**METROLINK Railway Order
An Bord Pleanála Oral Hearing**

ABP-314724-22

*Submission
Prepared by*

Client:	Union Investment Real Estate GmbH
Project Title:	Metrolink Oral Hearing
Document Title:	Written Submission – Module 2
Document/Job	JSA 22112 Ref Final

Figure 4.1: Model Layout with the Lift on the Northside of Grand Parade (Option A)

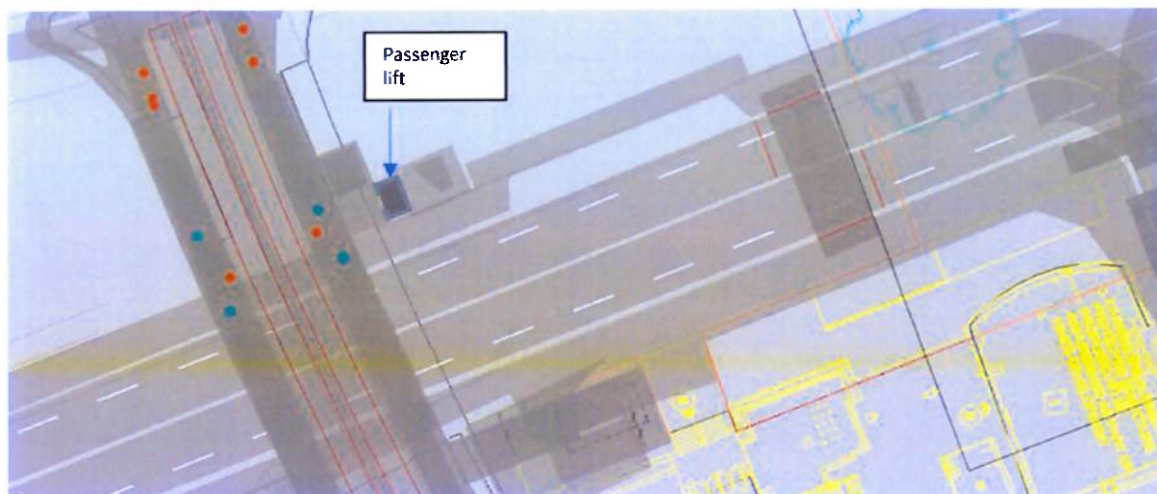
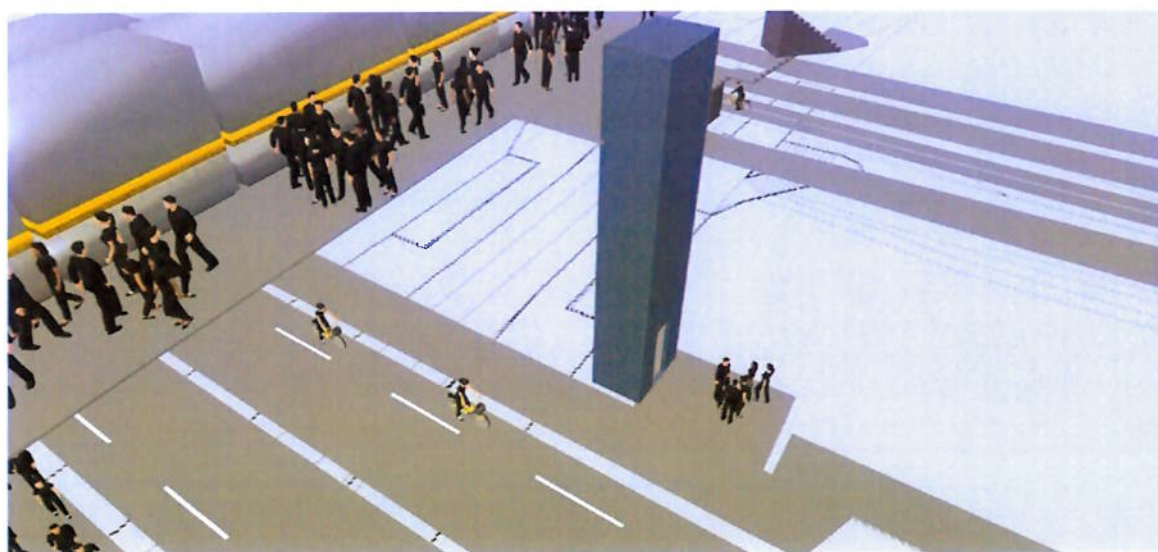
Figure 4.1). This configuration with no amendments to existing footpaths results in insufficient waiting space for the lift on the northern footpath of Grand Parade. This causes the model to gridlock with the existing footways. As a result of this, it is not possible to get results from the VISSIM model, and therefore a qualitative description of option performance cannot be provided.

Through iterative testing it has been found that in order for the footway to comfortably accommodate the anticipated passenger demand for the lift, a build-out of around 3.5m by 3.5m beyond the existing footpath extending into the Grand Canal is required. The build out is additional to the existing footpath width (3.1m) to avoid passengers queuing on the footway and causing congestion. With this provision in place, pedestrians waiting for the lift do not block the adjacent footway and the model operates without excess delay in this area. This option has been tested with the inclusion of the PRM drop-off on the northern side of Grand Parade as shown by the Railway Order application (see Figure 2.1). Without such a build-out the footway on the north side of Grand Parade becomes blocked by pedestrians waiting for the lift.

Fig 2.1E Sketch plan at street level with interchange

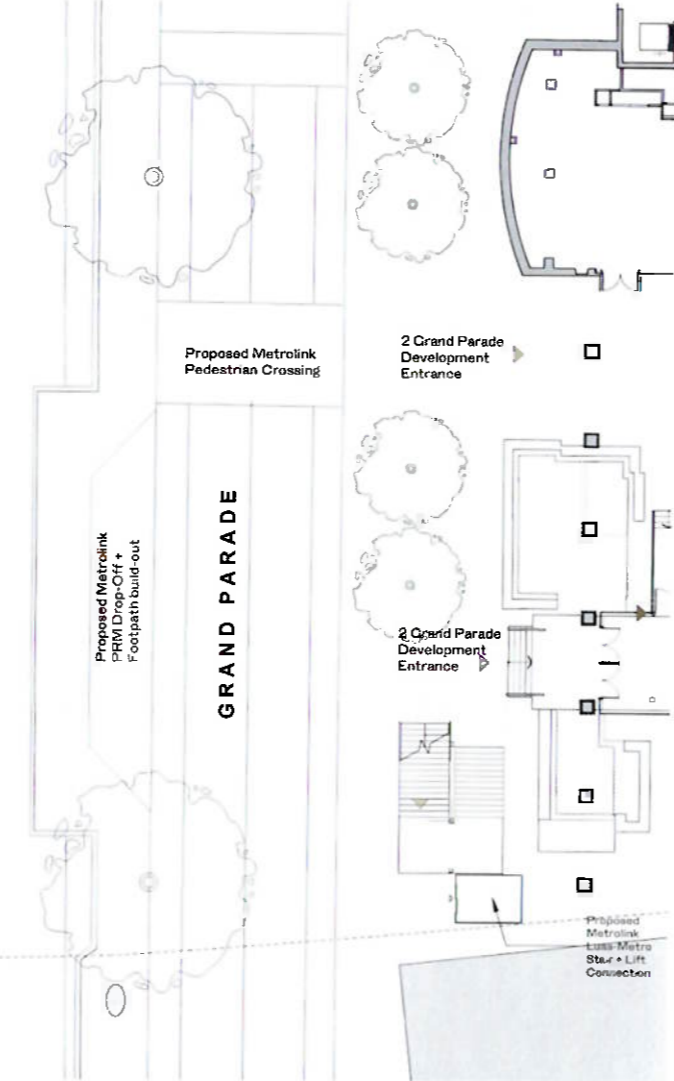
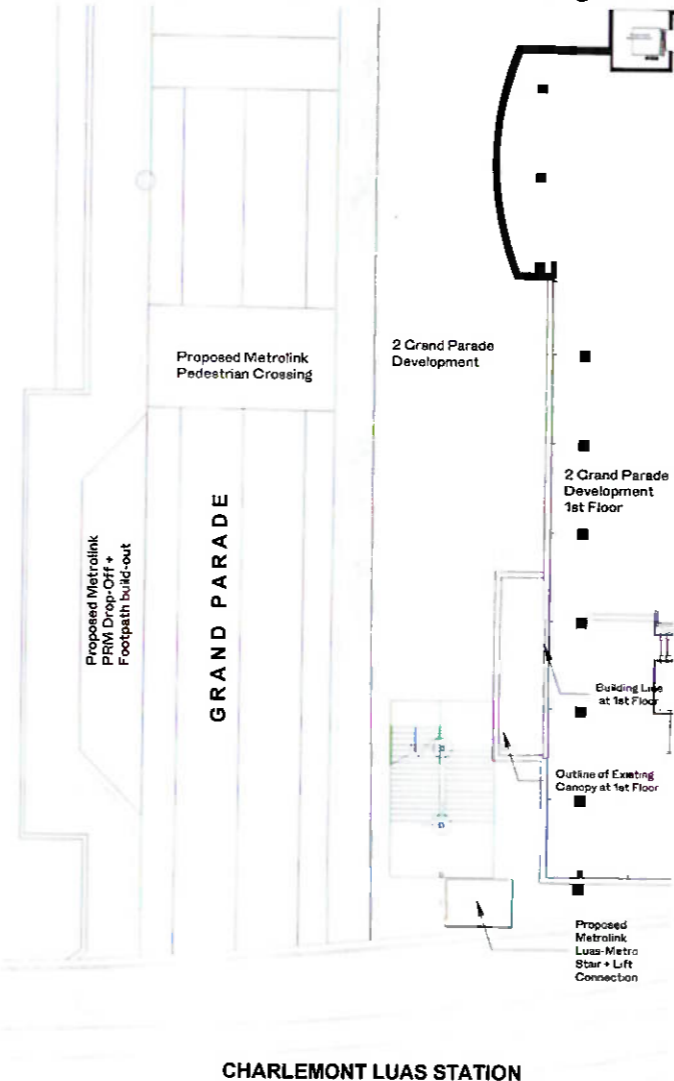
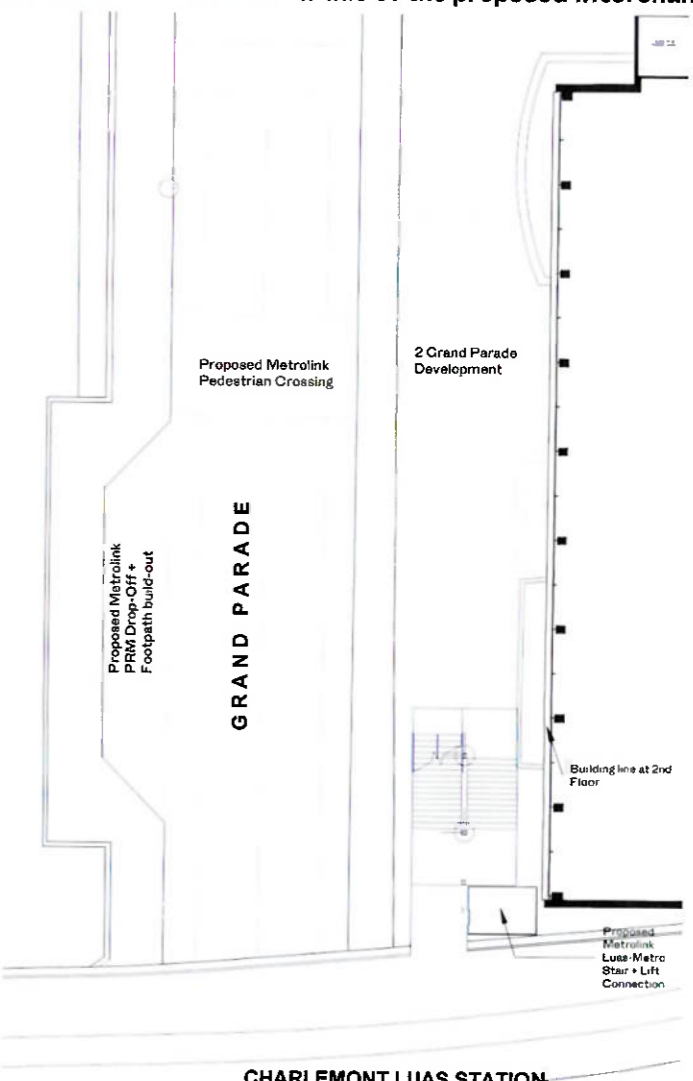
Refer to Figures 2.1E, F & G for ground, first and second floor sketch plans that demonstrate the proximity of the proposed interchange to the protected structure.

Fig 2.2A Extract from Report Ref. ML1-JAI-TRA-MS16_XX-RP-Y-00004| P01.2

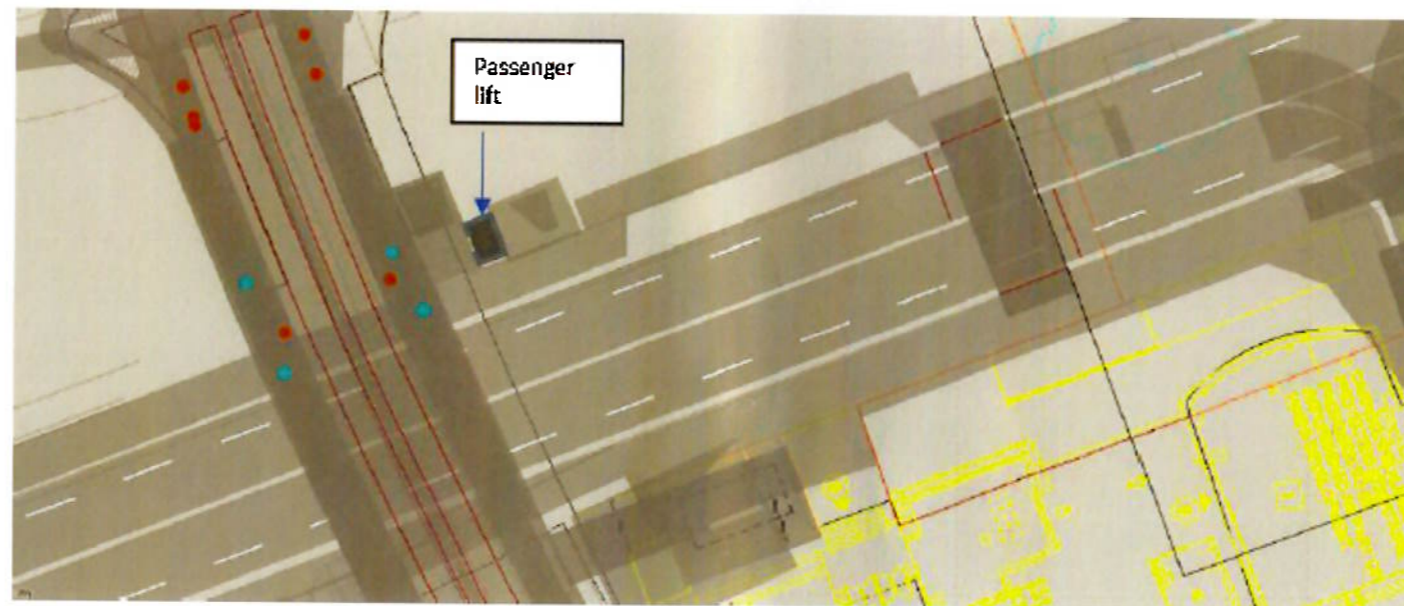
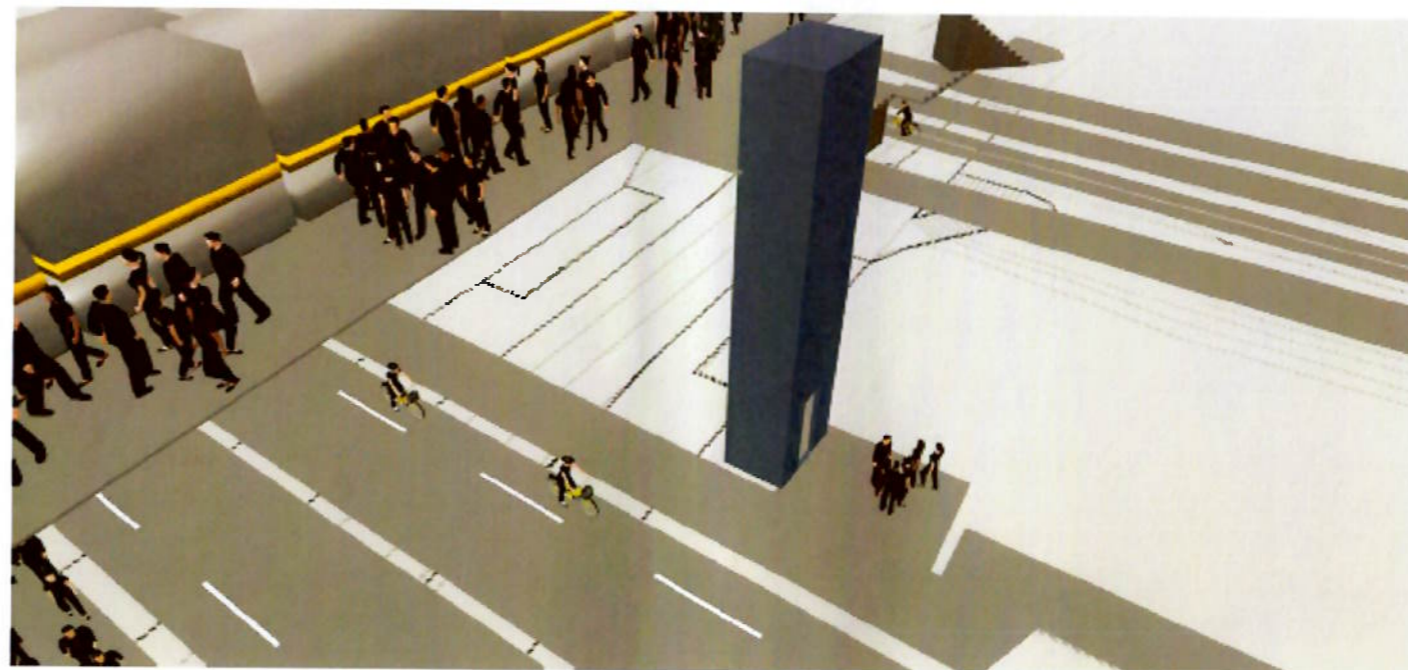
Refer to Figure 2.2A which is an extract from the report for this option that locates a through lift on the north side of Grand Parade.

This option would provide the opportunity to reduce the impact of the interchange and allow for the repositioning of the stair away from the main entrance and facade of the protected structure.

Fig 2.2B Proposed design intent at street level for the reconfigured stair and lift.

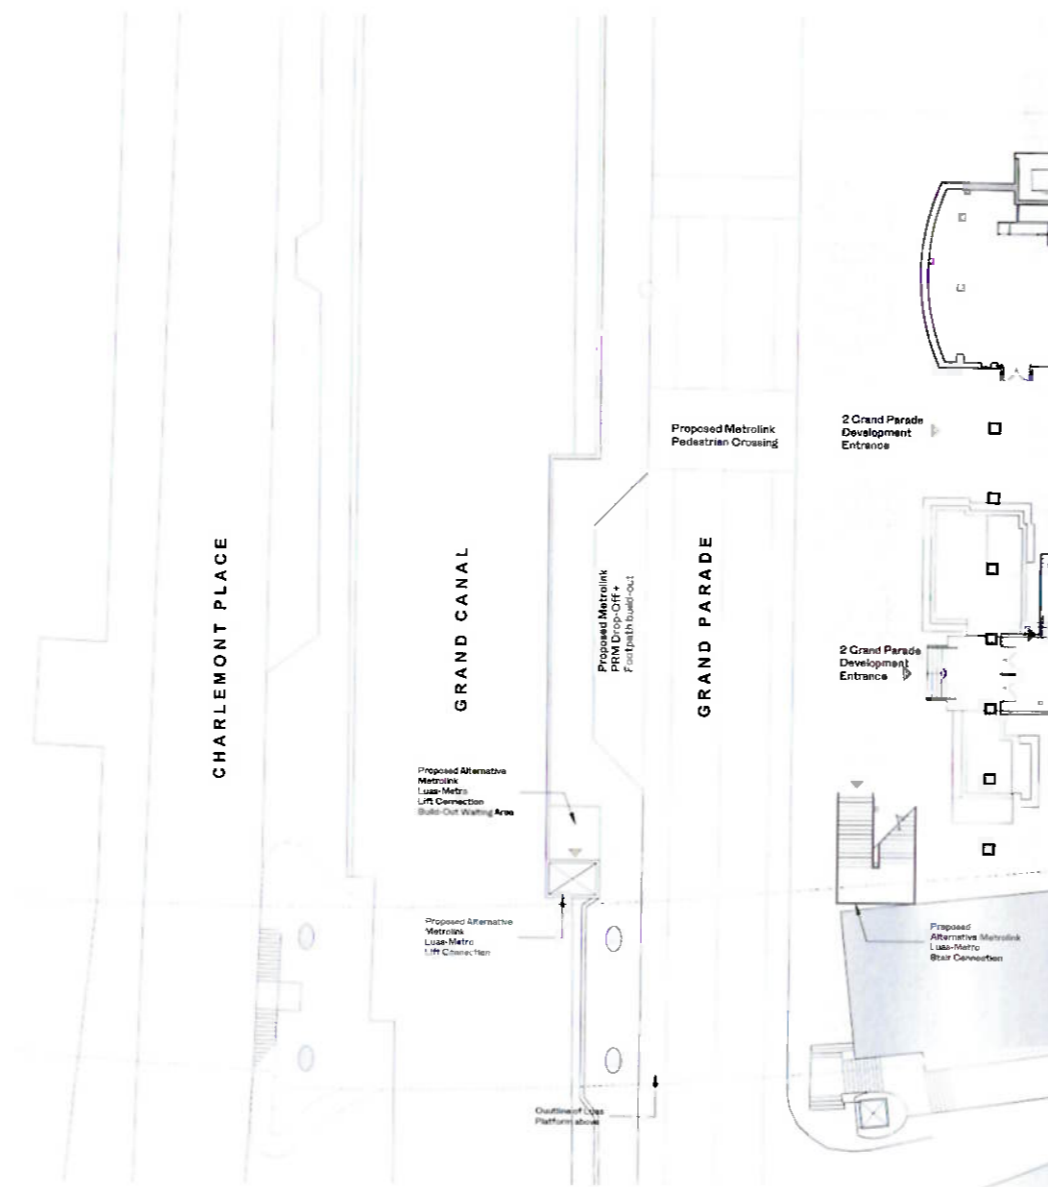
Refer to Figure 2.2B, C and D that demonstrate the potential alternative configuration of the stairs at street level and the lift re-located.

It should be noted that a build-out of approximately 3.25m over the canal is proposed by the Railway Order application to accommodate the proposed PRM (Persons with Reduced Mobility) drop-off adjacent to this location. The short continuation of this proposed build-out would provide a direct connection from the drop off area to the lift.

Fig 2.2E Proposed design intent at first floor for the reconfigured stair and lift.

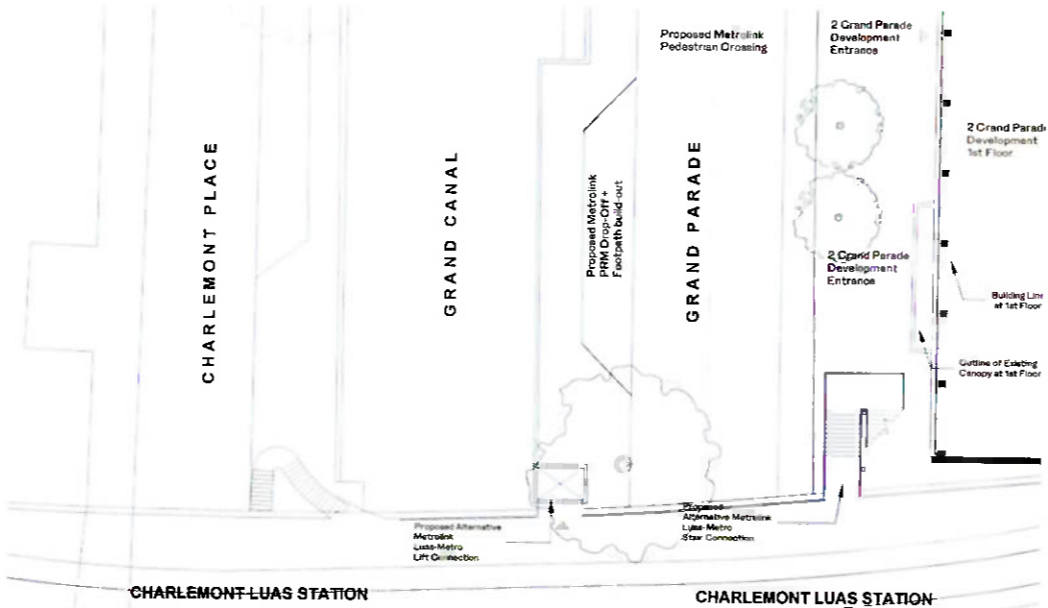
Refer to Figure 2.2E that shows the revised configuration at first floor level with the separation space between the stairs and the facade of protected structure increased as much as is potentially possible with the surrounding constraints.

Fig 2.2F Proposed design intent at second floor for the reconfigured stair and lift.

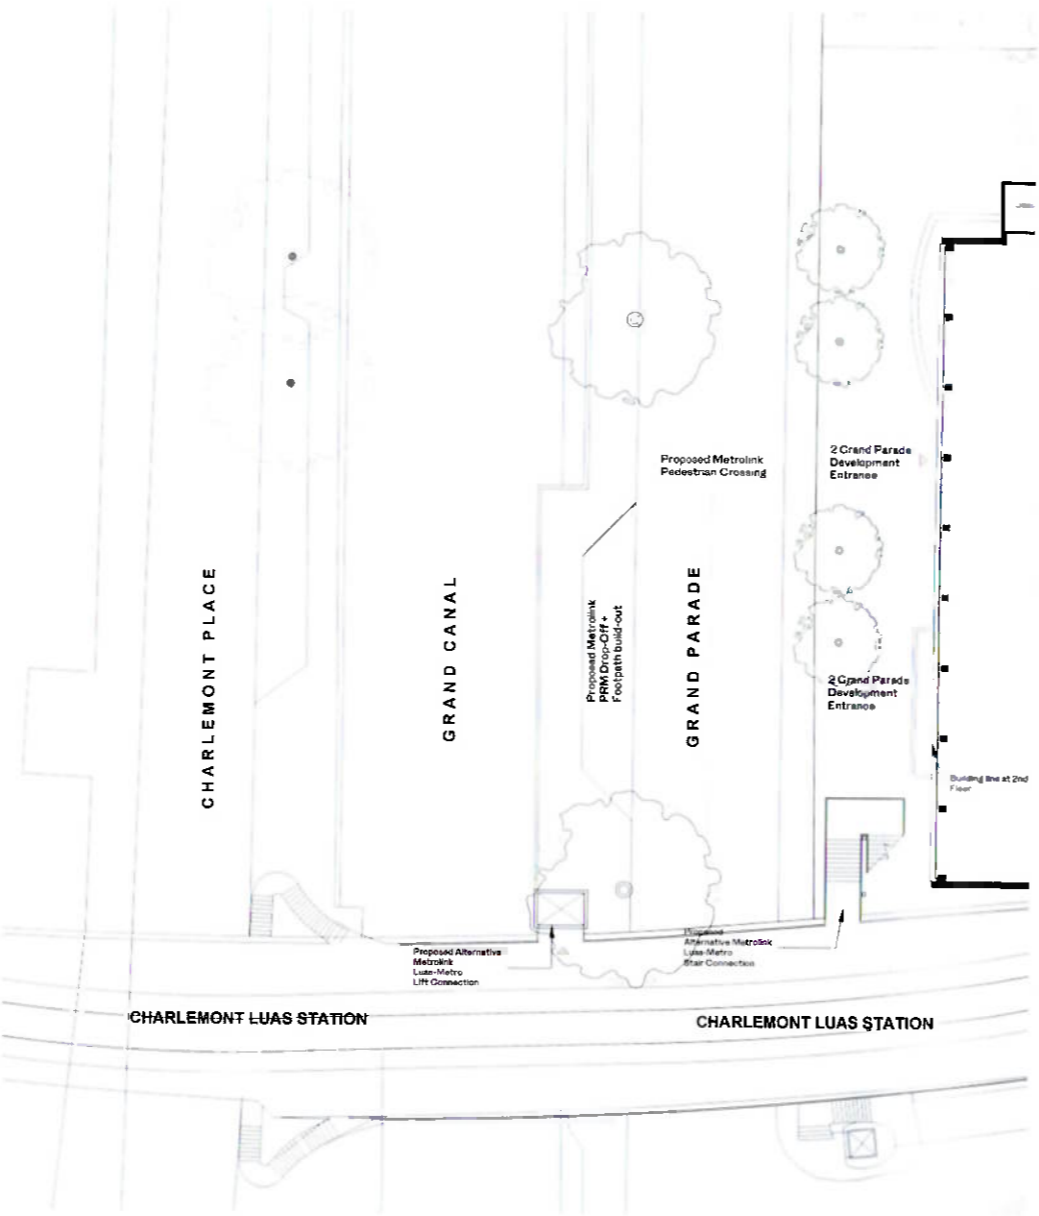
Whilst the alternative interchange design will still have a negative impact on how the protected structure is viewed and used, the impact would be reduced.

It is requested that TII be conditioned to submit a revised design and layout for the interchange between MetroLink and the Charlemont Luas Stop, providing for the relocation of the proposed passenger lift to the north side of Grand Parade, thereby facilitating the repositioning of the proposed stair so as to provide a greater separation distance between the stair and the main entrance and facade of the protected structure.

Fig. 2 This image shows the impact of the proposals on the front setting with views of the front façade – in particular the important architecture at the lower level – being completely obstructed by a new staircase and lift.

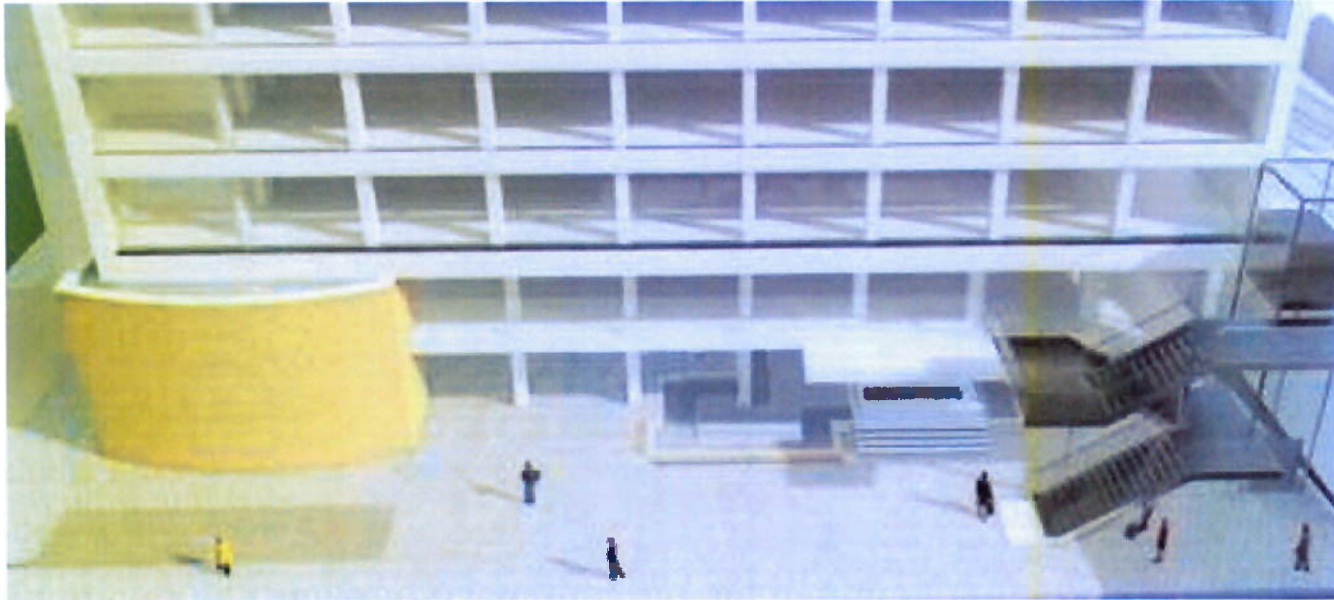
Clearly there will be a very significant impact on the most important aspect of this Protected Structure. The EIAR submitted by TII seems to concede this, when it notes that the impact arising from the proposals on the Protected Structure will be of a *'medium'* magnitude but that the impact will be *'very significant'*. The EIAR alludes to *'mitigation by design'* and suggests that the residual impact will be reduced to *'significant'* following mitigation. However, the EIAR offers no clue as to what this mitigation might be.
